**SERVICE BULLETIN**

**N° 189-329**

**ATA 62 – MAIN ROTOR BLADE IMPROVEMENT**

Figure 1

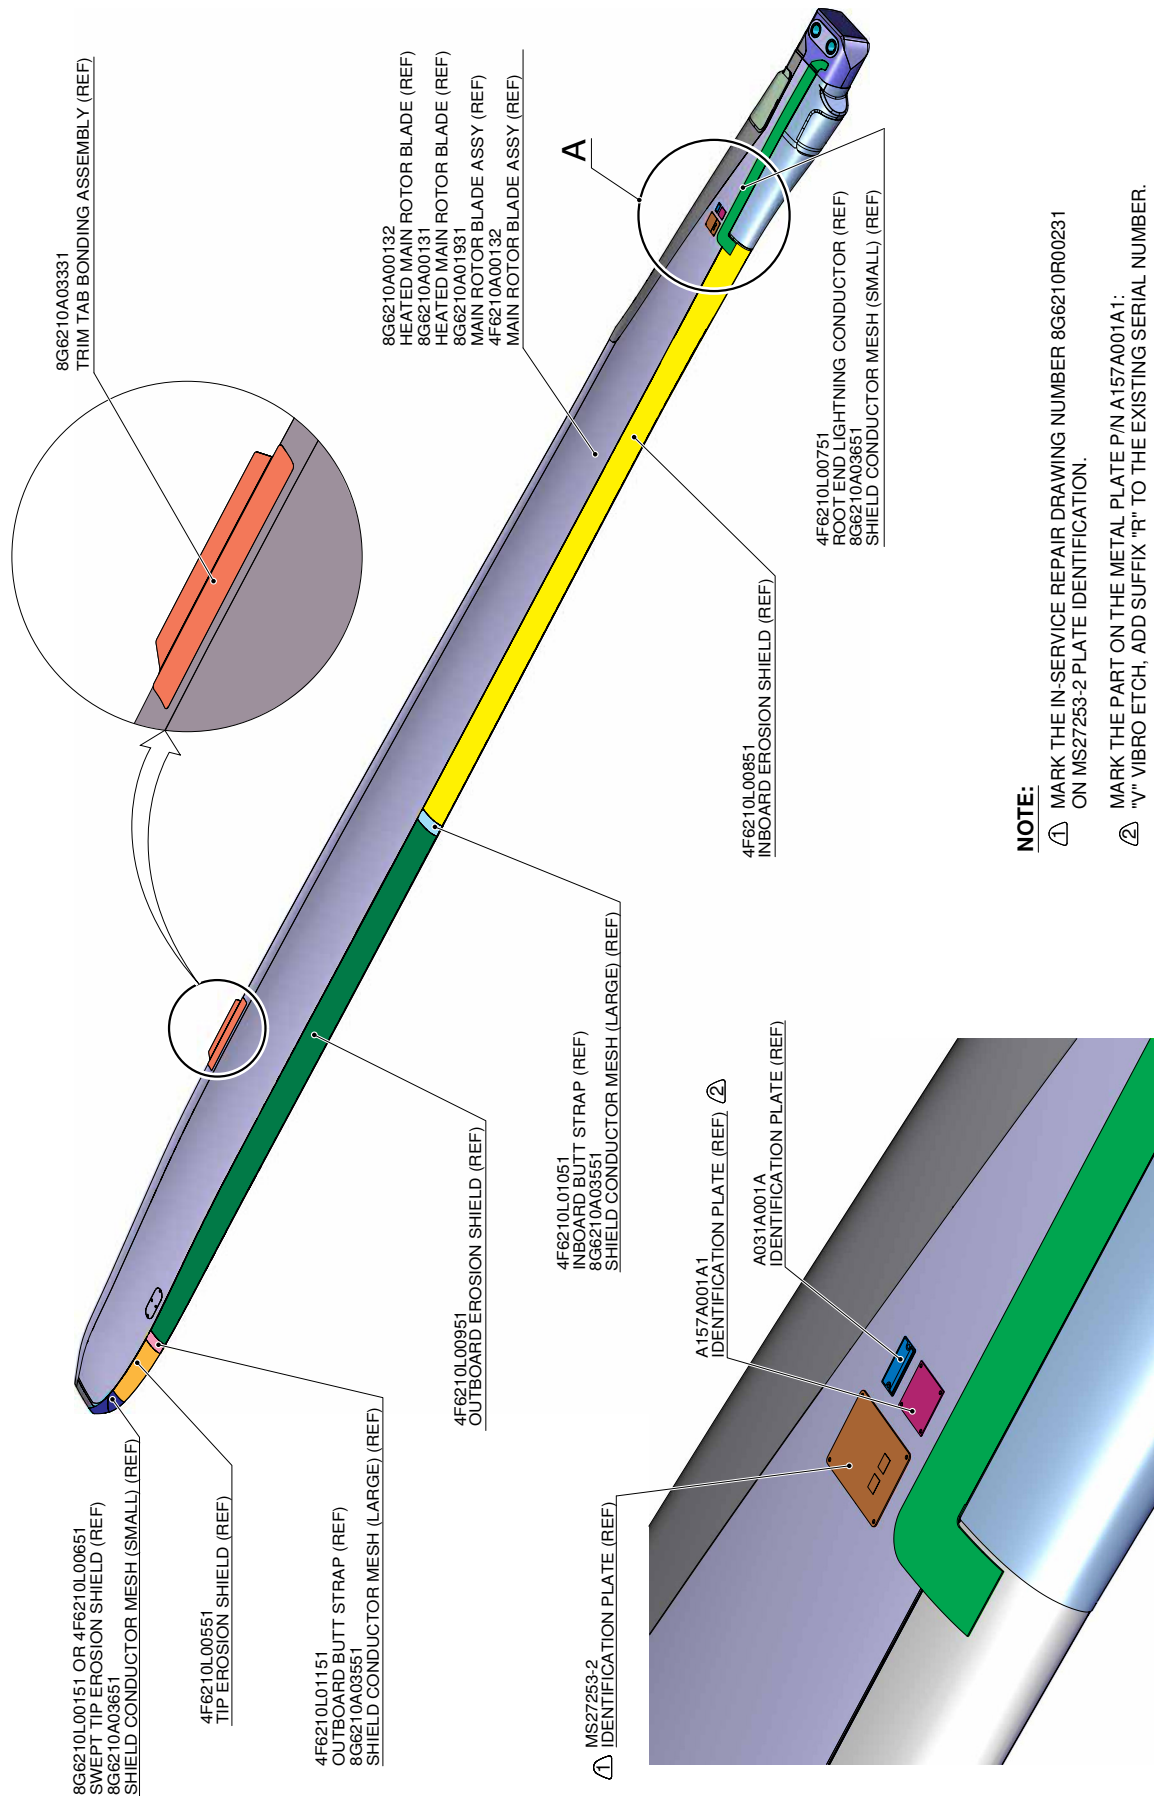
5. In accordance with applicable steps CR&OP DM 89-A-62-11-01-01A-921A-C and with reference to Figure 1, install the new trim tab bonding assy P/N 8G6210A03331.

7. In accordance with applicable steps CR&OP DM 89-A-62-11-01-00A-257A-C, perform the MR blade painting.
8. With reference to Figure 1, mark the part as described in the following procedure:

- 8.1 On the metal plate P/N MS27253-2:
    - mark repair drawing P/N 8G6210R00231, method "V", vibro etch;
    - final inspection stamp, method "T", rubber stamp ink marking.

- 8.2 On the metal plate P/N A157A001A1:
    - add suffix "R" to the existing serial number, method "V", vibro etch.
9. With reference to Figure 1, add suffix "R" to the existing serial number painted on the indicated area. Paint the suffix "R" as required (refer to Annex A for the formatting features requested by the applicable painting scheme).

**Figure 2**

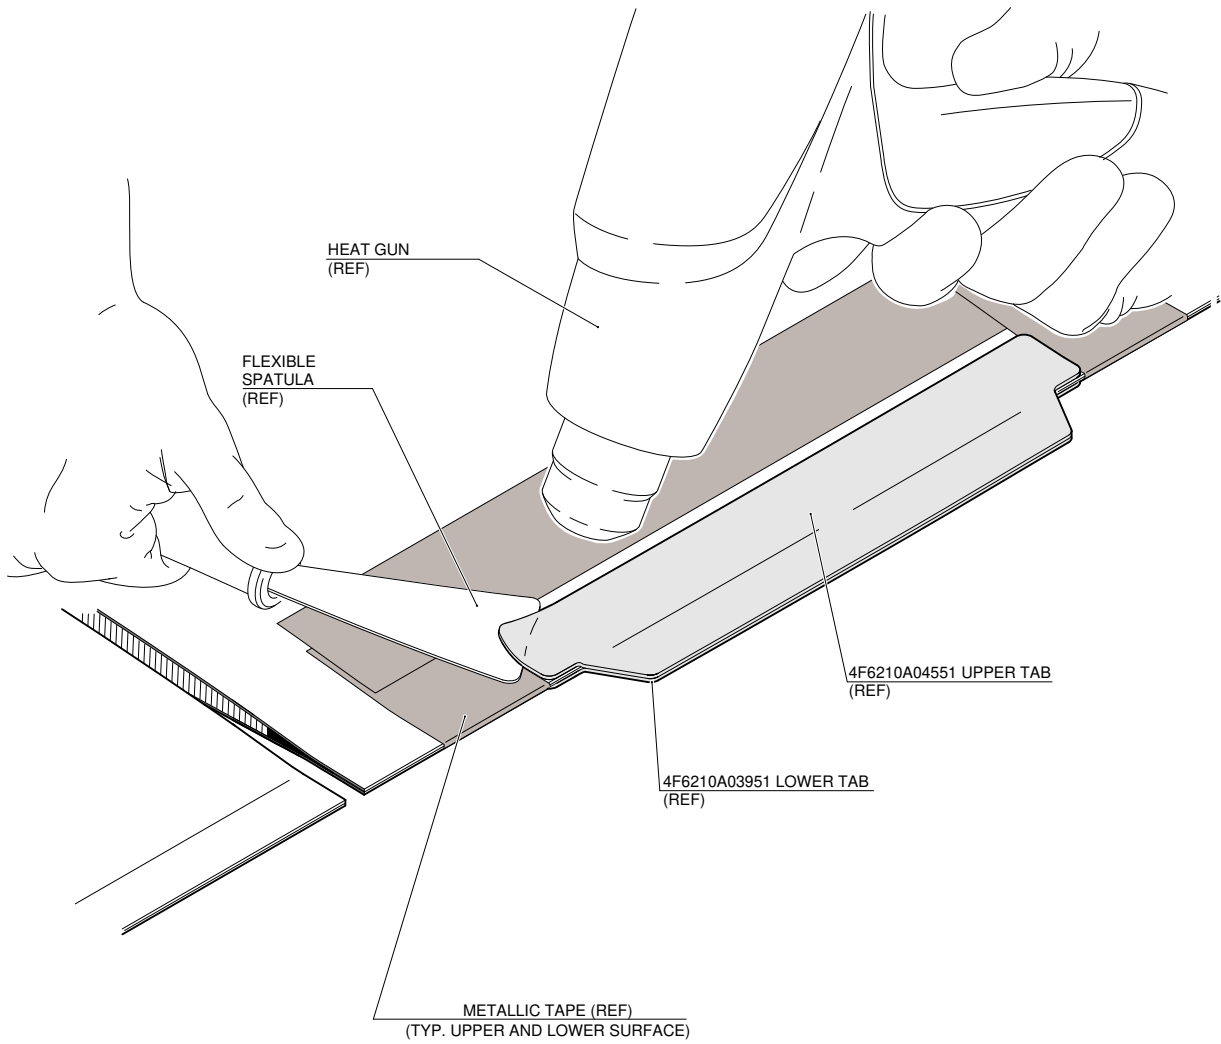
3. In accordance with CR&OP DM 89-A-62-11-01-00A-365A-C, perform the electrical continuity check on the main rotor blade.
4. With reference to Figure 2, remove the upper tab P/N 4F6210A04551 and the lower tab P/N 4F6210A03951 as described in the following procedure:

- 4.1 Apply the Metallic tape (C221) as protection from heat along the boundary of the trim tab assembly.

- 4.2 Locally heat the upper tab with the heat gun.

- 4.3 Starting from the blade skin carefully remove the upper tab from the main rotor blade and the lower tab with a spatula.
- 4.4 Starting from the blade skin carefully remove the lower tab from the main rotor blade.

- 4.5 Put a lint-free cloth (C011) soaked with the solvent (C005) on the trim tab area of the main rotor blade. Wait until the solvent softens the adhesive. Then, use a plastic scraper to remove the remaining adhesive from the trim tab area.

**Figure 3**

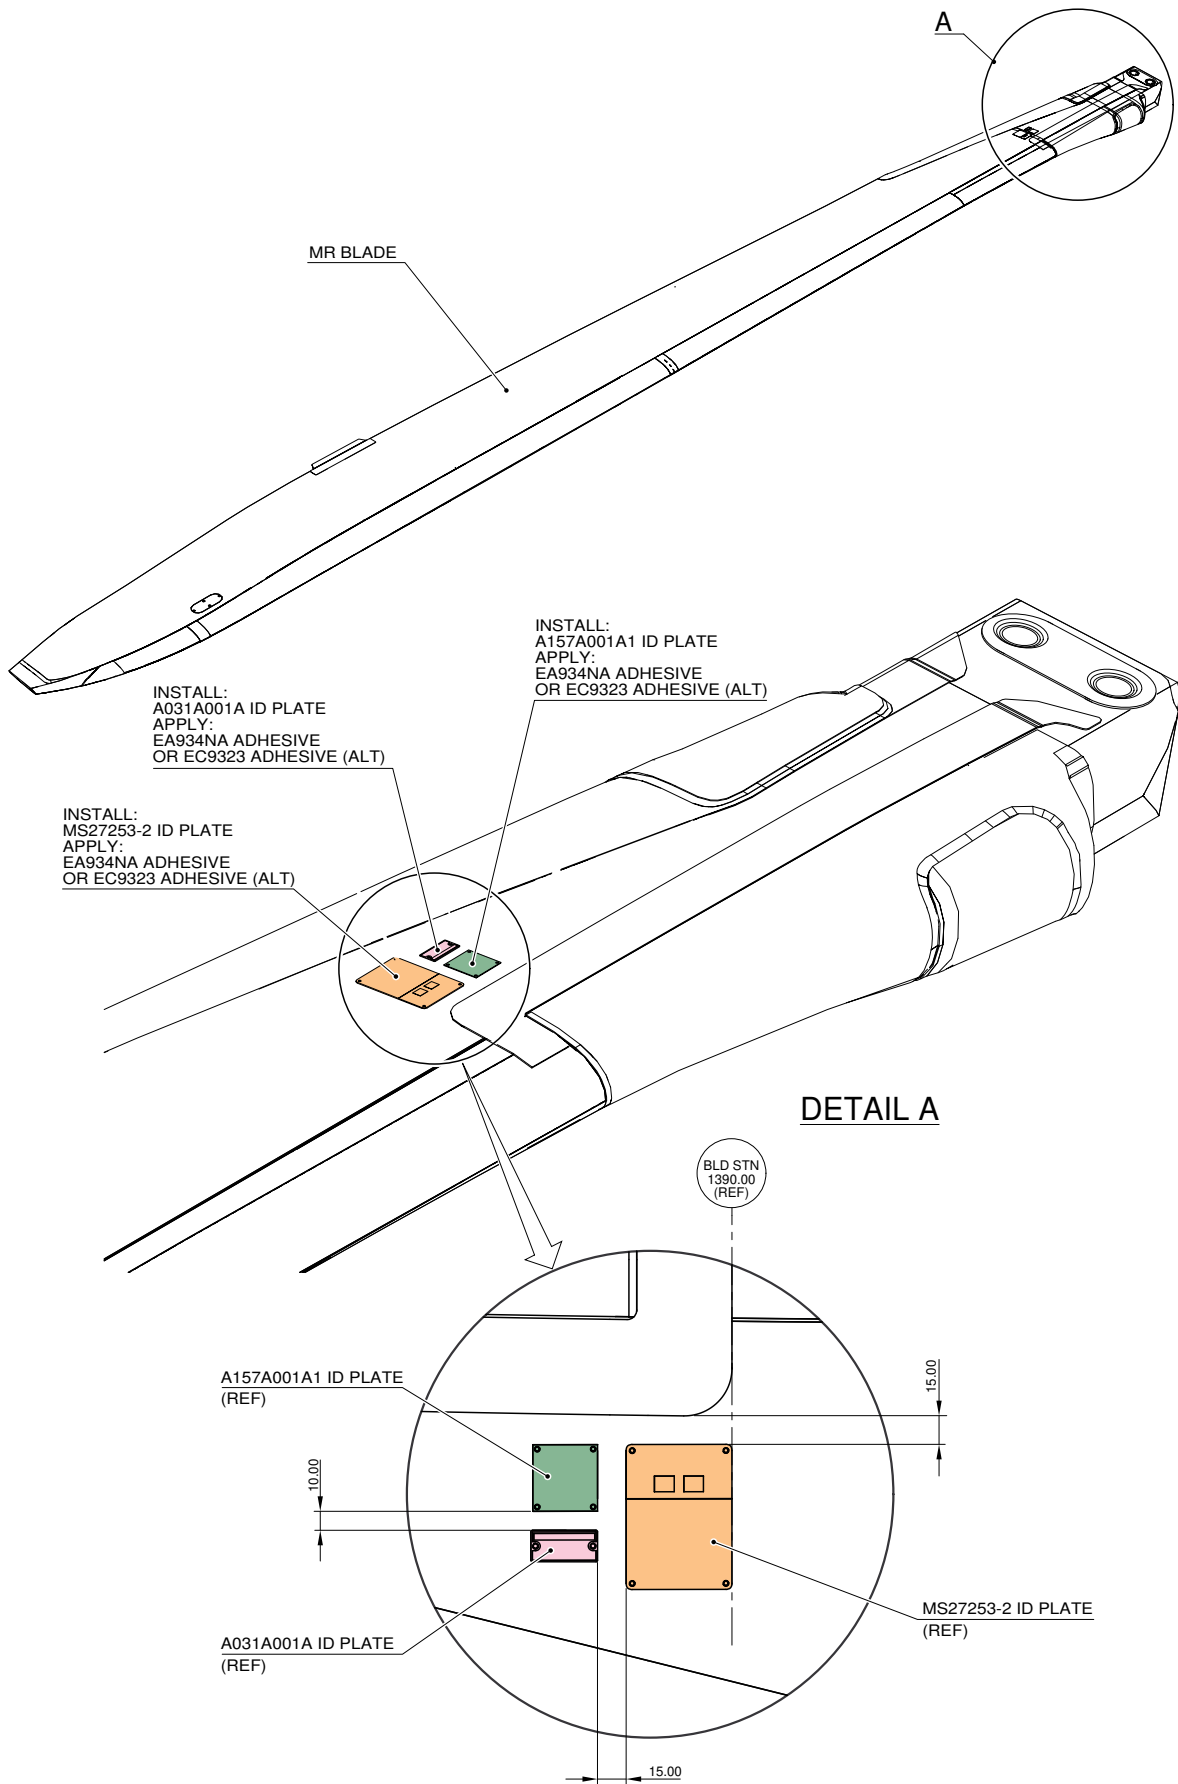
6. With reference to Figure 3, if the blade is not already compliant with SB189-215 or the ID plates P/N A031A001A, P/N A157A001A1 and P/N MS27253-2 are not already installed, perform the following procedure:

- 6.2 Install in the indicated positions ID plate P/N A031A001A, ID plate P/N A157A001A1 and ID plate P/N MS27253-2 by means of adhesive EA934NA (C054) or adhesive EC9323 (C487).

- 6.3 Mark on the new ID plates the following information:
  - Blade P/N and S/N;
  - Paint scheme P/N;
  - MFG date;
  - Inspection stamp;
  - Applied SB (if any).
